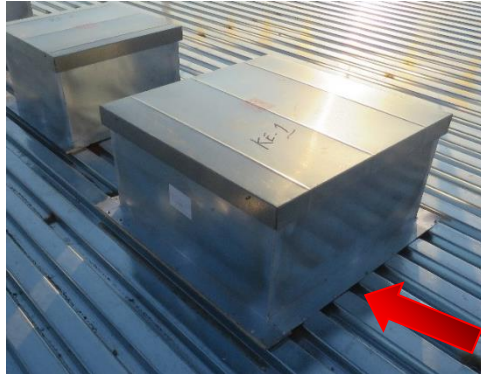
HVAC curbs that are being installed on metal deck creates interior pathways for air intrusion and air exfiltration under the metal deck which could create condensation under the roof.

We should be making sure that our scope sheets include installing a low rise SPF in the flutes (above & below) in order to close off any air pathway.
The installation of the SPF should be prior to the installation of the roofing.
